Value Engineering Study and MDOT Memo of Decision

**SUBJECT: Final Report of Value Engineering Services
I-20, From the Mississippi River Bridge to
East of the US 61N Interchange
Warren County
Project No. IMD-0020-01(181)
FMS 100367/002000
MDOT Work Assignment No. MAC-VA-2010-06
AMEC Project No. 6180-11-1028**

I-20, From the Mississippi River Bridge
to East of the US 61N Interchange
Project No. IMD-0020-01(181)
Warren County, Mississippi
May 23–27, 2010

Idea No.: A-12
Client: MDOT
Sheet 2 of 4

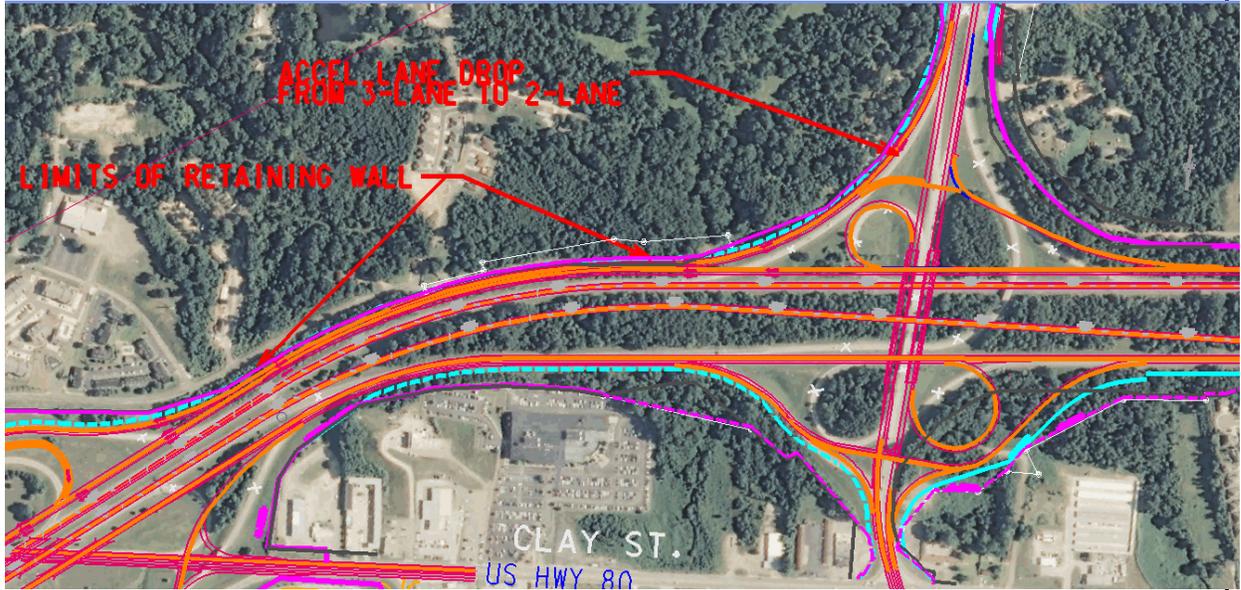
IDEA No.: A-12	Sheet No.: 1 of 4	CREATIVE IDEA: Eliminate 1-lane from the 5-lane On-ramp / CD lane merge – weave section in the west quadrant of the US 61N / I-20 Interchange.
--------------------------	-----------------------------	---

The current design includes a Northbound (NB) SR 27 / US 61N to Westbound (WB) I-20 on-ramp on the north side of the US 61N / I-20 Interchange. The on-ramp is in the NW quadrant of the Interchange. This on-ramp combines with the 2-lane Southbound (SB) US 61N to Westbound (WB) I-20 on-ramp as an additional lane. The 3-lane SB US 61N to WB I-20 on-ramp combines with the 2-lane WB I-20CD lanes to form a 5-lane weaving section on the north side of the Interstate (Approximately Station 250+00 to Station 270+00).

This recommendation creates an acceleration lane by tapering the inside lane of the 3-lane SB US 61N to WB I-20 on-ramp downstream of the median crossover approaching the 2-lane WB I-20 CD lanes. This concept results in a 4-lane weaving section (Approximately Station 250+00 to Station 270+00).

The low volume of NB SR 27 to WB I-20 traffic that would use the median crossover on-ramp and merge with the SB US 61N to WM I-20 lanes can easily be accommodated before getting to the 4-lane weaving section. The on-ramp merge (lane drop) removes one lane from the complex north side merge / weaving area and therefore simplifies the weaving movements while reducing the amount of required retaining wall adjacent to the ROW within the same weaving area limits. This concept improves traffic operation and saves costs.

Further evaluation determined the 5-lane merge / weave section for the WB CD lanes could be reduced to a 3-lane weaving section. The SB US 61N and NB SR 27 ramp to the North CD Road would have a lane for the US 61 traffic and an added lane for the NB SR 27 left turning traffic entering the ramp. To the west of the US 61 N / SR 27 Interchange, the North CD Road would have 1-lane at the gore where the North CD Road and the 2-Lane SB US 61 / NB SR 27 ramp to I-20 W become concurrent. The \$2,276,000.00 potential savings appears reasonable for this good idea.

Idea No.: C-2
Client: MDOT
Sheet 2 of 4

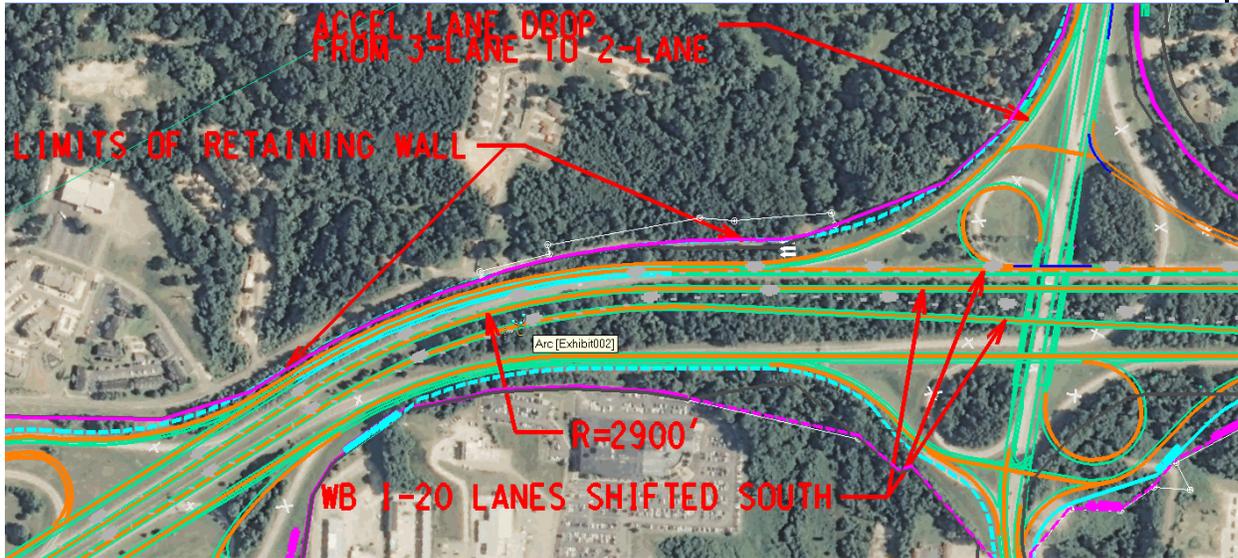
IDEA No.: C-2	Sheet No.: 1 of 4	CREATIVE IDEA: Shift the WB I-20 roadway / CD lanes at the US 61N / I-20 Interchange south placing the new CD lanes on the old existing WB I-20 footprint.
-------------------------	-----------------------------	---

Proposed Change:

Idea No.: G-5
Client: MDOT
Sheet 2 of 4

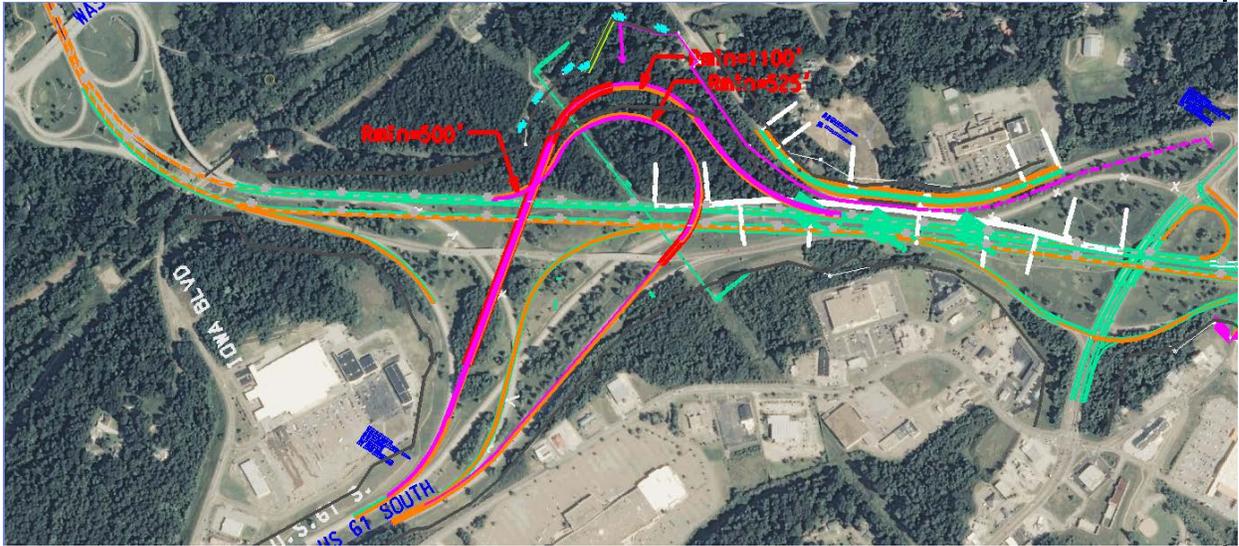
IDEA No.: G-5	Sheet No.: 1 of 4	CREATIVE IDEA: Reconfigure the US 61S / I-20 Trumpet Interchange.
-------------------------	-----------------------------	---

Original Concept: The current design to revise the I-20 / US 61S directional Interchange on the west end of the project would construct a Trumpet Interchange between Station 50 and Station 80. This concept eliminates the existing “left” on and off ramps. The current Trumpet design requires new R/W on the north side of I-20, comes very close to the Military Park property, and contains long ramps with long flyover bridges.

Proposed Change: This recommendation would reverse the curve for the NB US 61 to WB I-20 on-ramp. This concept also tightens the WB I-20 to SB US 61S off-ramp around the outside of the new reversed curve on-ramp.

Justification: The VE design provides right on / off connectivity. This concept keeps the south end of the new on-ramp on the existing NB US 61S on-ramp alignment longer and reverses the ramp curve to turn left and connect to WB I-20 near Station 55. The revised design reduces the length on the on-ramp and flyover bridge section of the ramp. It reduces the amount cut on the north side of I-20 and better follows the existing terrain as it connects to I-20. This concept put the WB on-ramp connection on a down grade improving merging.

The SB off-ramp is also shifted inward toward the revised WB on-ramp. This brings the ramp closer to the hill on the north side of I-20 thereby reducing the length of the flyover bridge. The ramp shifts reduce R/W needs, reduce impacts to the Military Park, and reduce project cost.

The change in the NB US 61S to WB I-20 on-ramp reduces the distance between the gore areas for the US61S to WB I-20 on-ramp and the WB I-20 to Washington Street off-ramp.

After making further evaluation of the suggested change, the advantages and disadvantages of the suggested change were compared to those of the original concept.

The main advantages of the suggested change are: (1) it has less right of way impacts on the north side of the interchange; and (2) it requires less length of bridge. The main disadvantages of the suggested change are: (1) approximately 1,000 feet of weaving distance is lost for the added lane provided for this maneuver between this interchange and the exit gore at the Washington Street / Warrenton Road Exit 1A Interchange where the added lane is dropped; (2) drivers are required to negotiate a non-standard type ramp with reverse horizontal curves and rotating rates of superelevation; and (3) unless additional expensive right of way is acquired for a detour in the southeast quadrant of the US 61 South Exit 1B Interchange, the I-20 East exit ramp to the Halls Ferry Road Exit 1C Interchange must be closed during the bridge construction.

The main advantages of the original concept are: (1) approximately 1,000 feet more weaving distance is gained for the I-20 West added lane provided for this maneuver between this

interchange and the Washington Street / Warrenton Road Exit 1A Interchange; (2) drivers are more familiar with the loop exit design used for a Trumpet Interchange; and (3) the maintenance of traffic plan keeps the exit ramp open for I-20 East traffic at the Halls Ferry Road Exit 1C Interchange.

Idea No.: I-1
 Client: MDOT
 Sheet 2 of 4

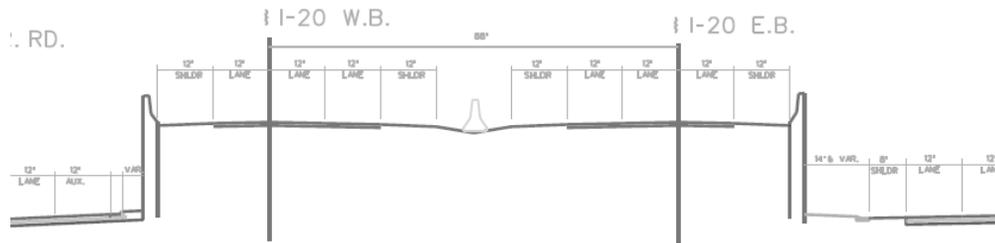
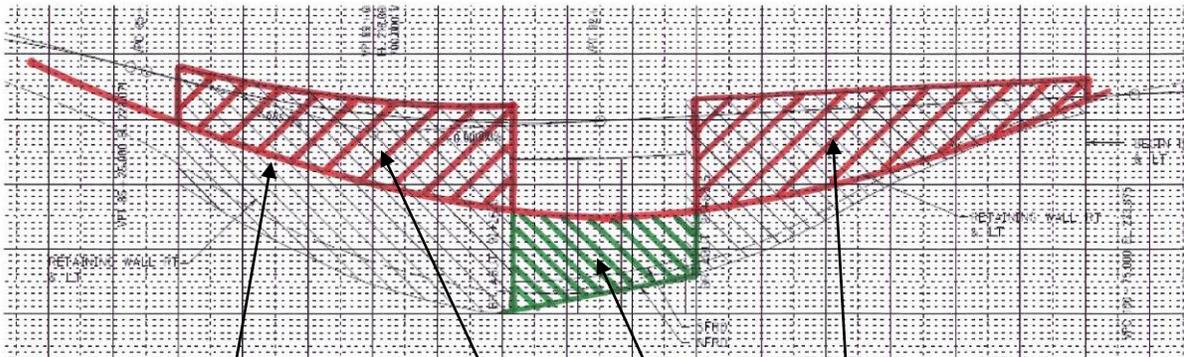
IDEA No.: I-1	Sheet No.: 1 of 4	CREATIVE IDEA: Eliminate the two Frontage Road crossovers and allow Frontage Road connectivity only at the Interchange cross streets.
-------------------------	-----------------------------	--

Proposed Change: This recommendation would eliminate the Frontage Road crossovers allowing Frontage Road connectivity only at the Interchange cross streets.

Likely profile change
 without crossovers.

Additional Walls

Wall Reduction due to
 profile change.

Idea No.: R-2
Client: MDOT
Sheet 2 of 4

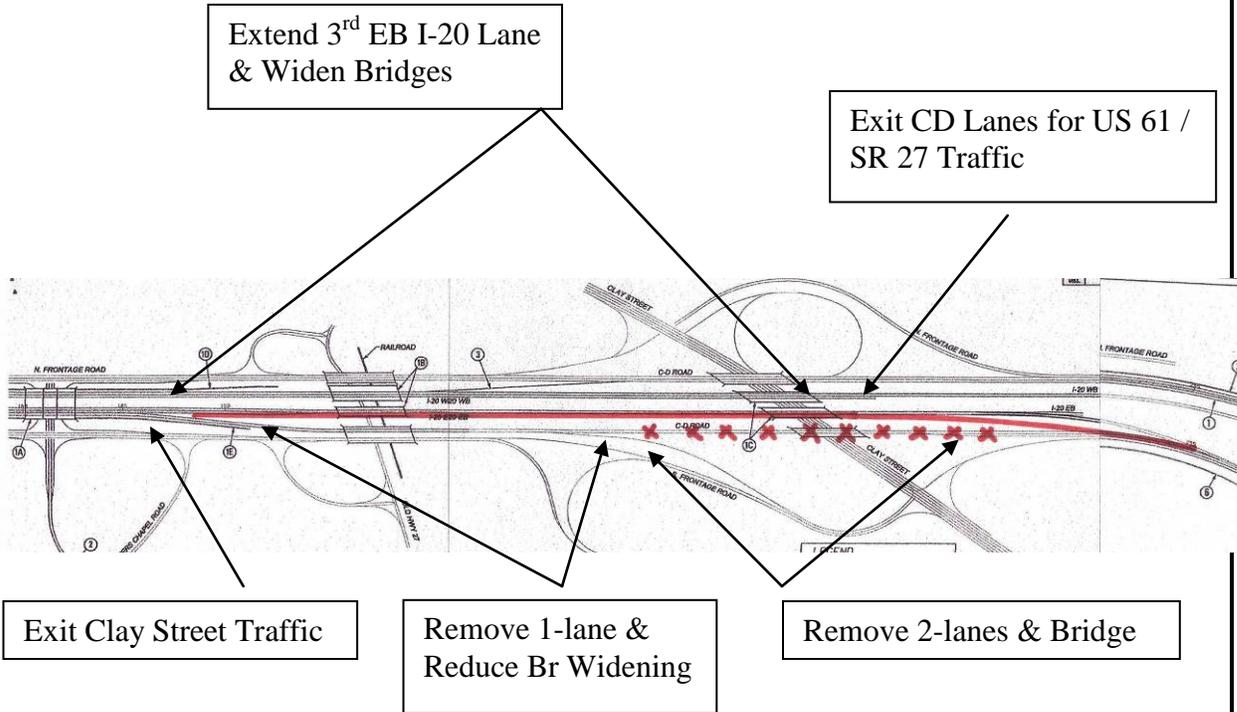
IDEA No.: R-2	Sheet No.: 1 of 4	CREATIVE IDEA: Modify the EB CD lane / Clay Street off-ramp configuration.
-------------------------	-----------------------------	--

Proposed Change: This recommendation would split the EB CD off-ramp configuration. This concept would split the CD off-ramp traffic allowing only Clay Street traffic to exit I-20 at the original location (east of the FR crossover at Station 200) while keeping NB US 61N / SB SR 27 traffic on the mainline roadway to a new “second” exit starting just east of the I-20 bridge over Clay Street. This concept substantially shortens the CD road.

Justification: Providing separate off-ramps would simplify roadway signage, provide a more “standard” exit ramp configuration for the motorists, and eliminate merging Clay Street traffic with the CD lanes which primarily serve the NB US 61N / SB SR 27 exiting traffic.
